**MAJOR PROJECT ASSESSMENT  
ALTERATIONS AND ADDITIONS TO  
STAR CITY CASINO COMPLEX, PYRMONT  
& NEW HOTEL ON THE SWITCHING  
STATION SITE  
Proposed by SYDNEY HARBOUR CASINO  
PROPERTIES PTY LTD  
MP08\_0098**

Director-General's Environmental Assessment Report  
Section 75I of the  
Environmental Planning and Assessment Act 1979

January 2009

Figure 4 – Hotel tower elevation relative to existing Casino tower height.

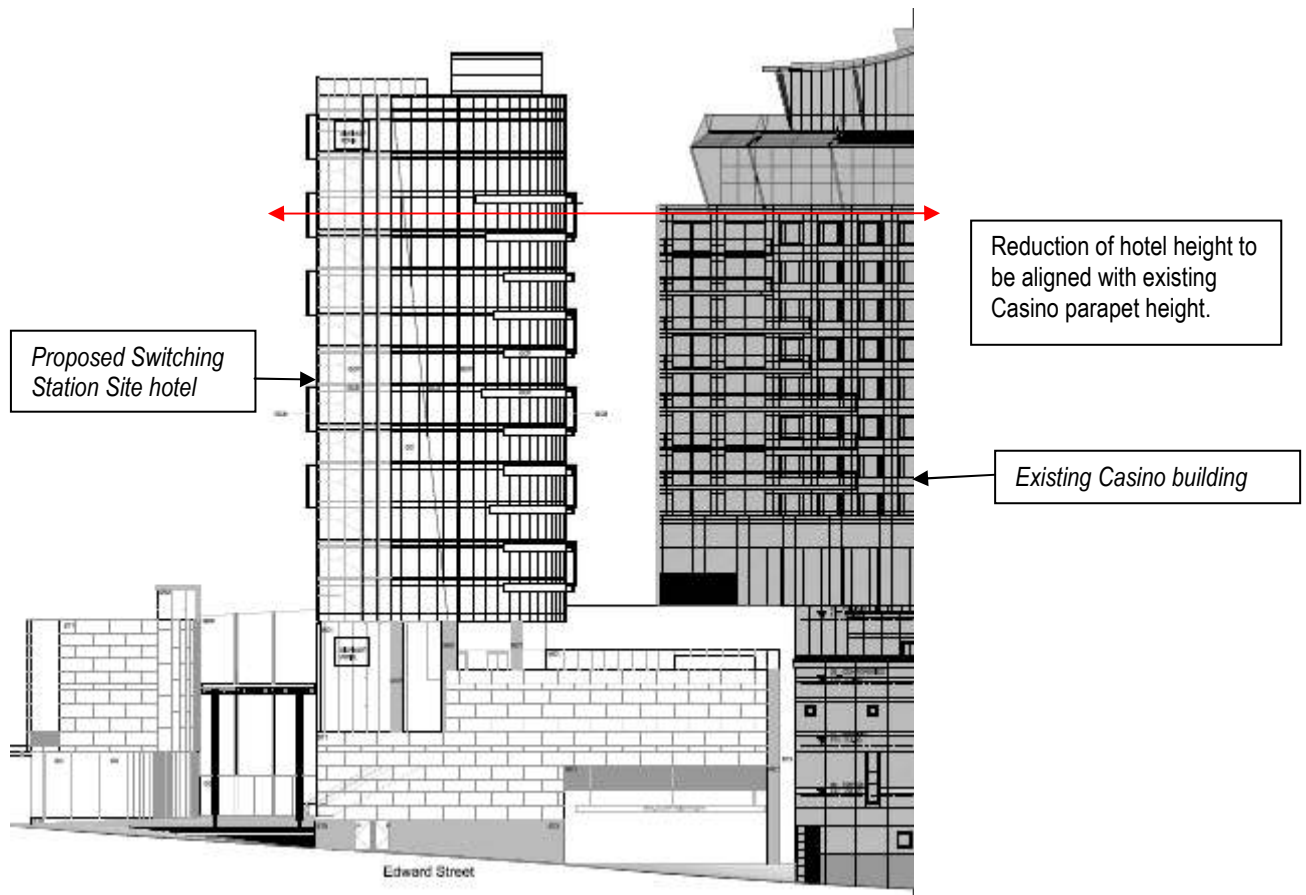
Reducing the height of the hotel tower by 3 levels does not comply with the 28 metre control however it will reduce the height to a maximum RL of 151.00, equal to a height of 40.1 – 43.38 metres. This 8.5 metre reduction, together with the proposed setback of the tower from the podium frontage, is reasonable and would reduce the visual dominance of the corner building, reduce overshadowing impacts and ensure that its scale is contextually appropriate by mediating between the existing casino buildings and the adjacent significantly lower development in Pyrmont. The reduction in height would also achieve an appropriate urban design relationship between the new building and the existing Casino tower buildings to ensure that they do not read as a single wall of buildings, particularly when viewed from longer distances from Pyrmont Bay and the CBD, and for the Casino towers to remain as landmark elements. The reduction in height will result in the hotel tower matching, or being slightly lower than, the height of the parapet of the Casino tower buildings, taking into account the façade portion which is higher than the uppermost slab level. This will assist in the achievement of an appropriate urban design relationship and the mediation between adjacent built form. (Refer to Figure 4).

On this basis it is recommended that a condition be imposed requiring a reduction in the height of the hotel by 3 levels, or a lesser reduction in height subject to the upper-most structure of the hotel being no greater than RL 152.8, which is the height of the adjacent casino tower parapet.

Figure 11: Detailed analysis  
at 9.00am, 22 June

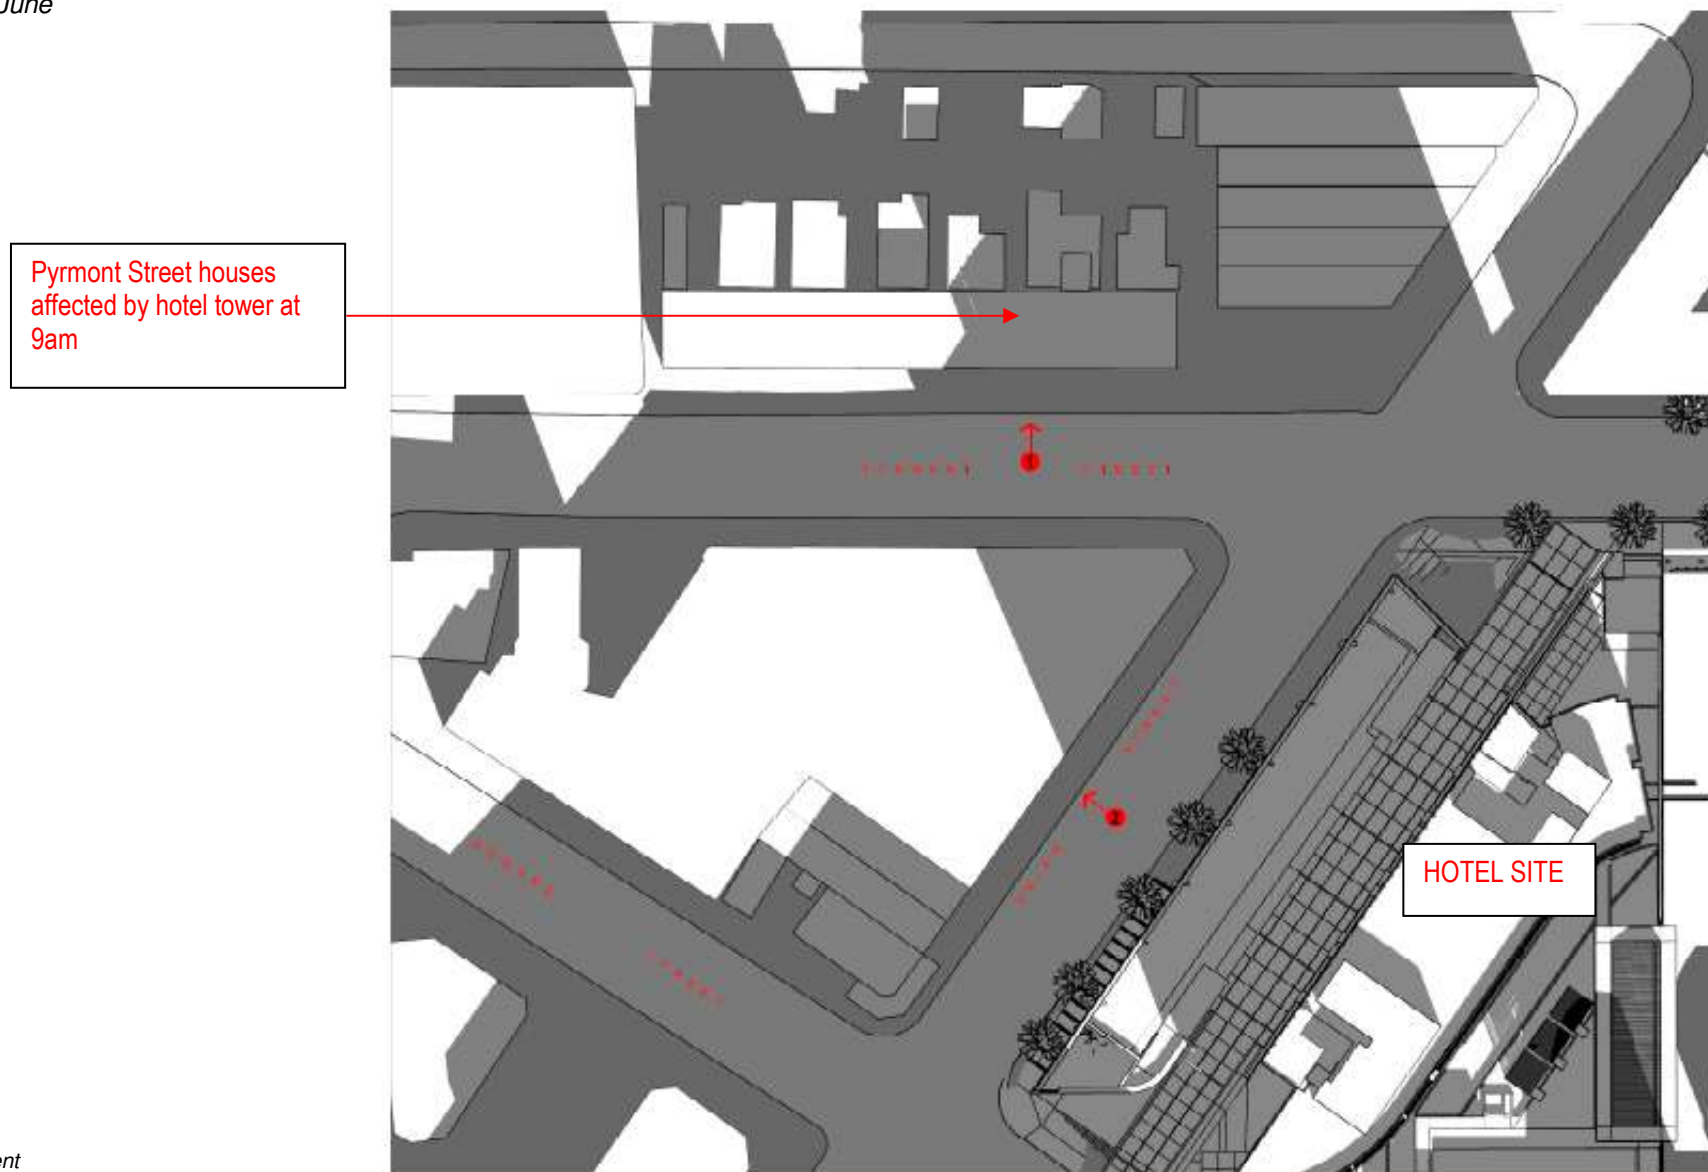
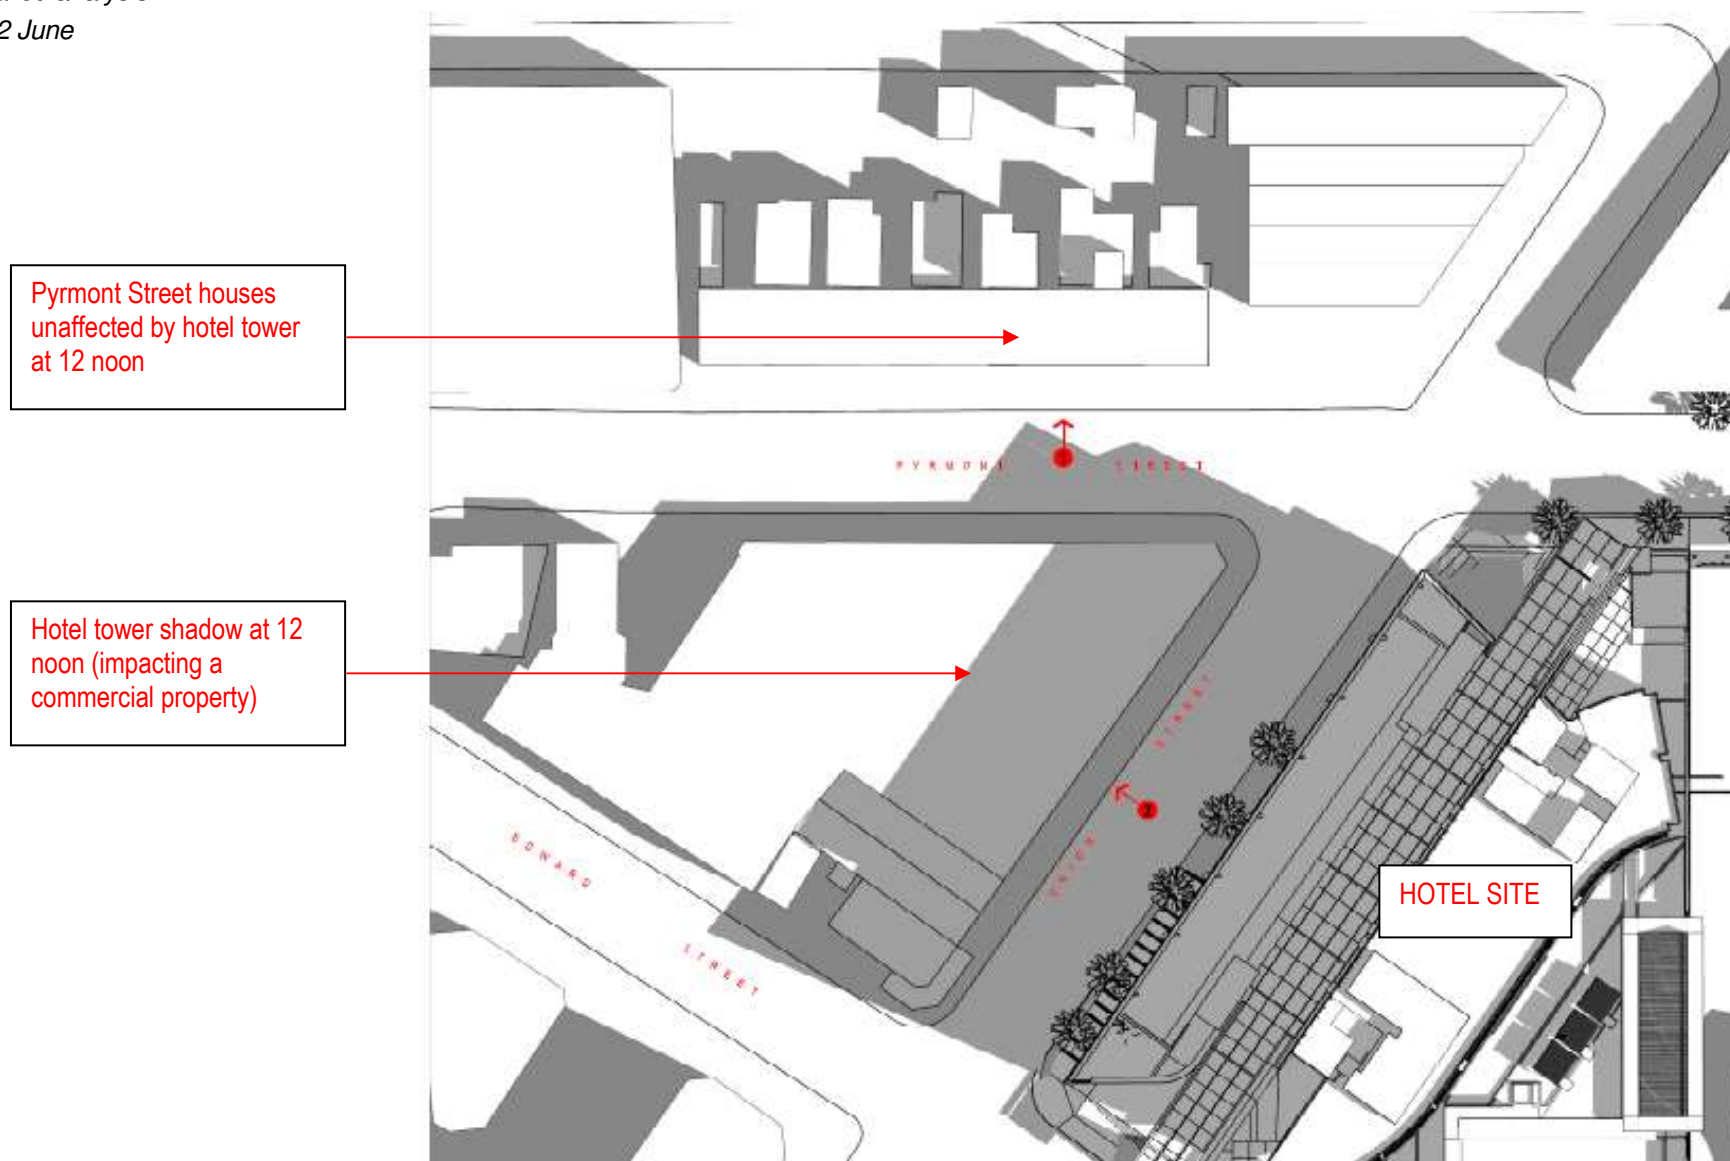
Additional solar access analysis submitted with the PPR demonstrates that at 9am in mid-winter proposed hotel building on the Switching Station Site will overshadow the fronts of residential properties on Pymont Street (refer Figure 11). These properties overshadow their own rear gardens at this time.

Between 12 noon and 3pm in mid-winter the proposed hotel tower casts shadows on commercial buildings in Union Street (Refer figure 12).

On this basis the proposed new hotel development will not significantly create adverse overshadowing to adjoining areas. The recommended reduction of the hotel tower by 3 levels will further reduce its overshadowing impacts.
